**CITY OF NOVI CITY COUNCIL**  
**APRIL 20, 2020**

**SUBJECT:** Consideration for tentative approval of the request of Trowbridge Companies for Morgan Place, JZ19-17, with Zoning Map Amendment 18.371 to rezone property in Section 36, located on the east side of Haggerty Road, north of Eight Mile Road, from Freeway Service (FS) to General Business (B-3) with a Planned Rezoning Overlay (PRO), and corresponding Concept Plan. The property consists of approximately 0.48 acres and is currently vacant land. The applicant is proposing to develop an approximately 2,420 square foot single story building.

## PLAN REVIEW CENTER REPORT

**Review Date:** March 02, 2020  
**Review Type:** PRO Concept Plan and Preliminary Site Plan (1<sup>st</sup> Revision)  
**Project Name:** **JZ 19-17 with Rezoning 18.730 & JSP 19-21: Triangle Place**  
**Plan Date:** 01-14-20  
**Prepared by:** Sri Ravali Komaragiri  
**Contact:** **E-mail:** skomaragiri@cityofnovi.org **Phone:** 248.735.5607

Landscape Plan

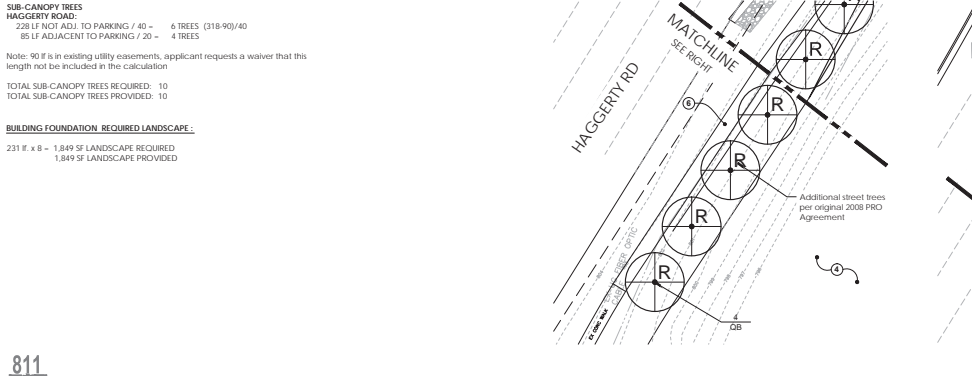
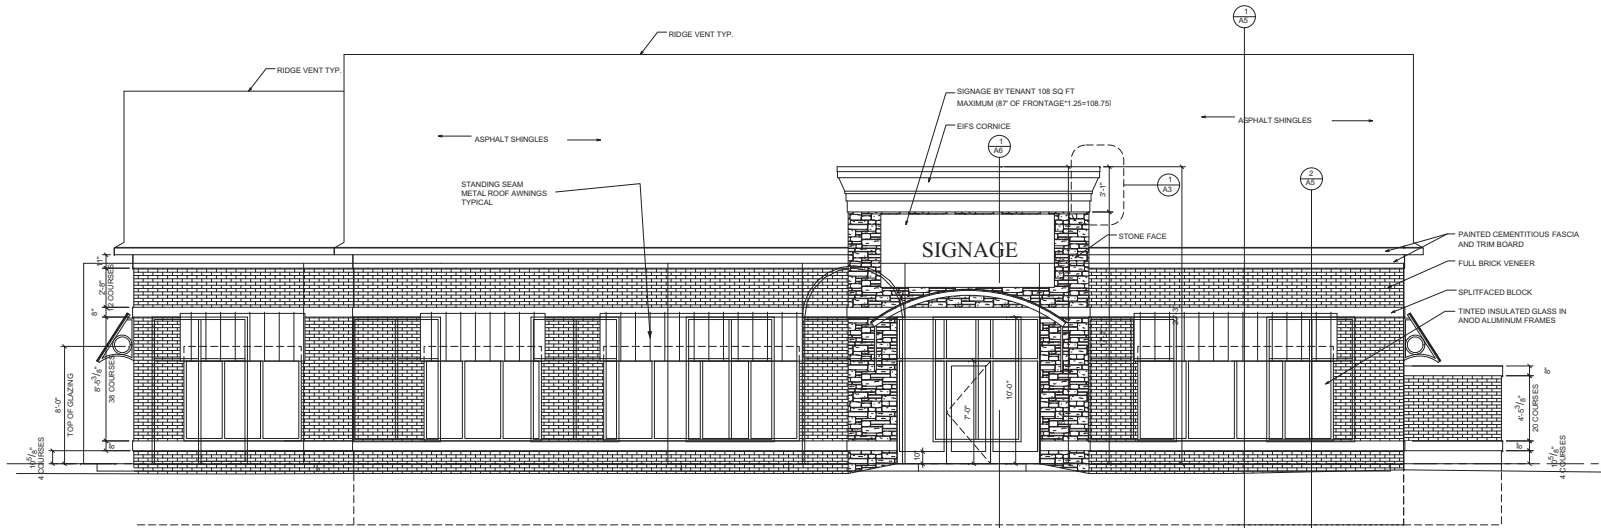
Please show these deviations on Sheet L-1.

Please show these deviations on Sheet L-1.

1. The landscape deviations will be added to sheet L-1
2. Additional ornamental grasses will be planted north of the sidewalk along the parking lot to screen from Haggerty Road.
3. The tree in the northeast corner of the parking lot will be moved to the northwest corner.
4. City of Novi standard note #7 on sheet L-2 will be changed to read 3 months instead of one year
